DOG RIVER DRIVE SUBDIVISION

APPLICATION NUMBER 2 DATE October 17, 2019

REQUEST Subdivision

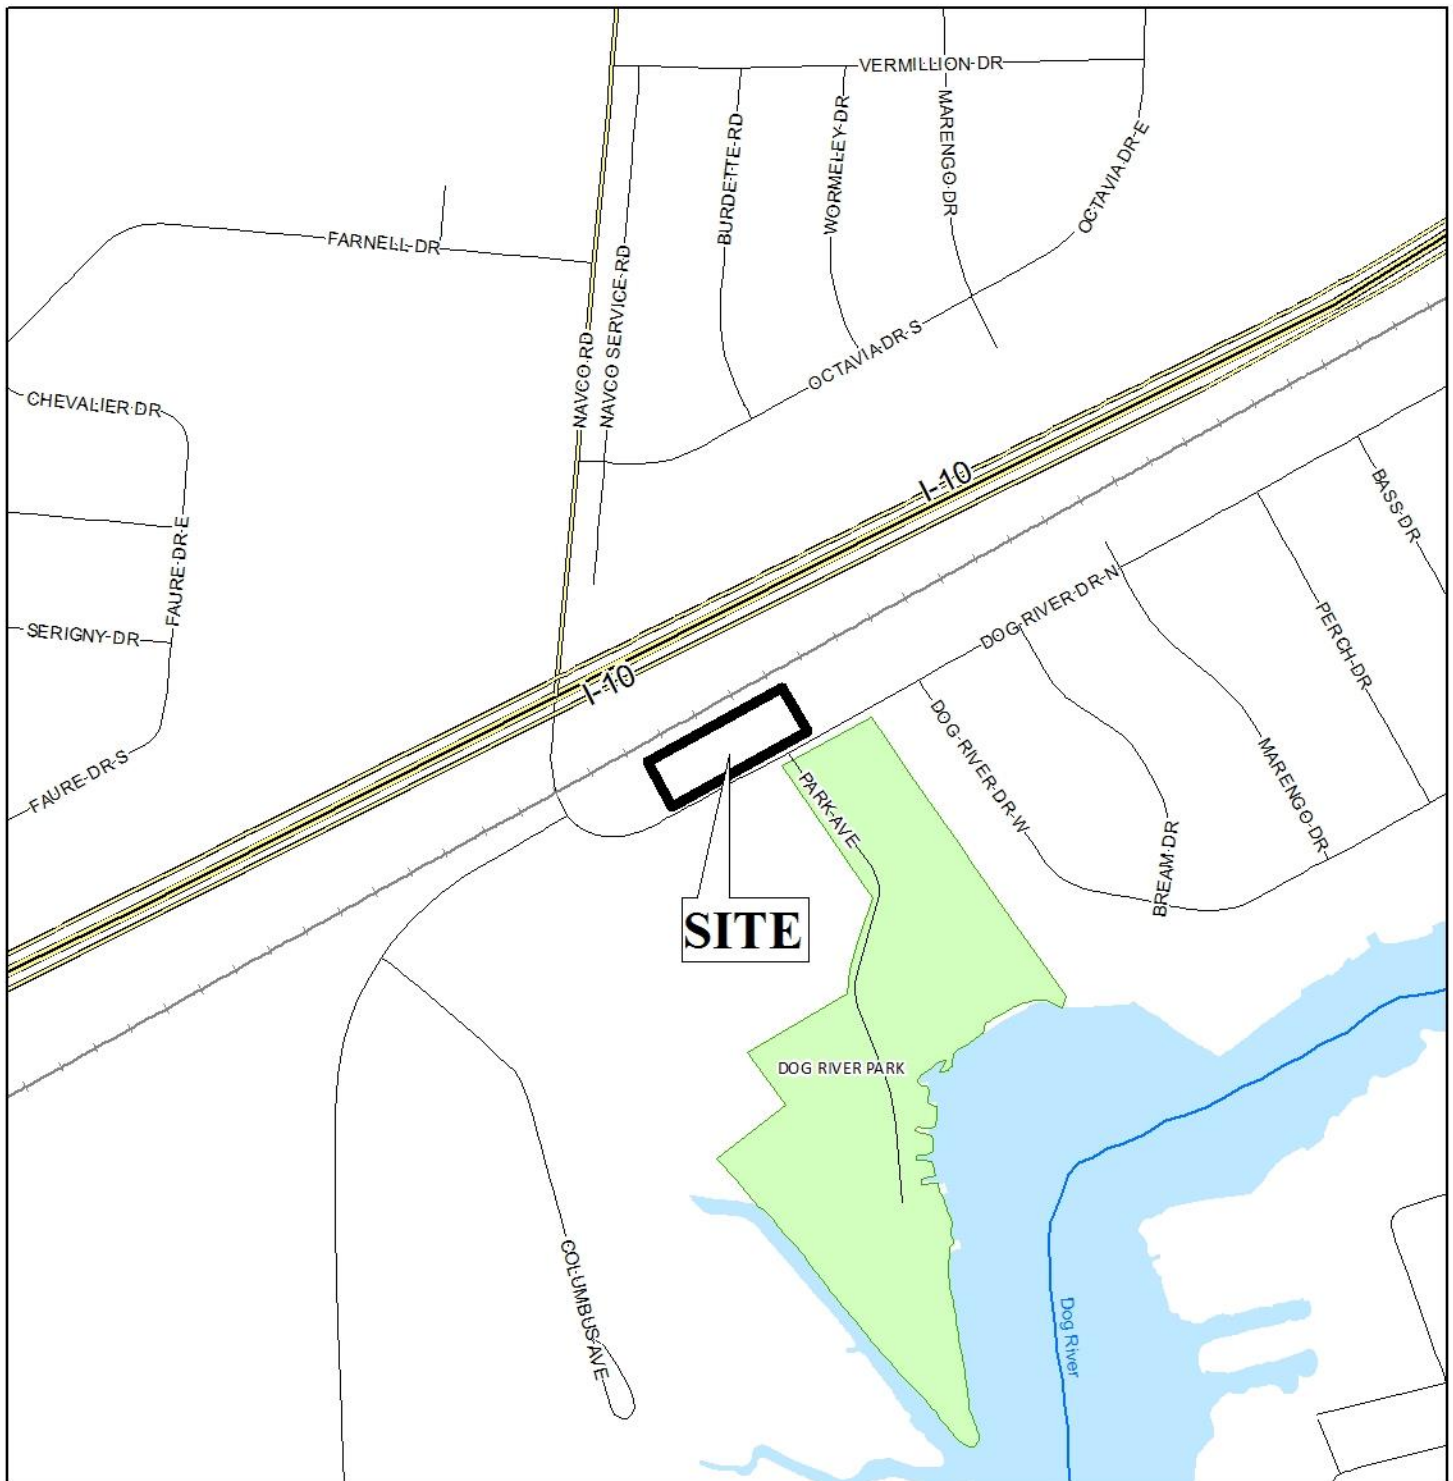
Both proposed lots front Dog River Drive North a minor street with no curb or gutter and an existing right-of-way of 50 feet. A 60 foot right-of-way is required for a minor street without curb and gutter, thus the Final Plat should be amended to show dedication to provide 30 feet from the center line of Dog River Drive North.

The preliminary plat does not depict the required 25-foot minimum setback requirement. As such, if approved, the Final Plat should be amended to illustrate the required 25 foot setback requirement for both Lots One and Two.

The lot size labels in both square feet and acres should be retained on the Final Plat, adjusted for any required dedication, or a table should be furnished on the Final Plat providing the same information.

As a means of access management, a note containing the Traffic Engineering comments should be placed on the Final Plat.

- 1) dedication to provide 30 feet from the center line of Dog River Drive North;
- 2) addition of the required 25 foot minimum front yard setback along frontages for both Lots One and Two, from any required dedication;

- 3) retention of the lot size labels in both square feet and acres on the Final Plat, adjusted for any required dedication, or the furnishing of a table on the Final Plat providing the same information;
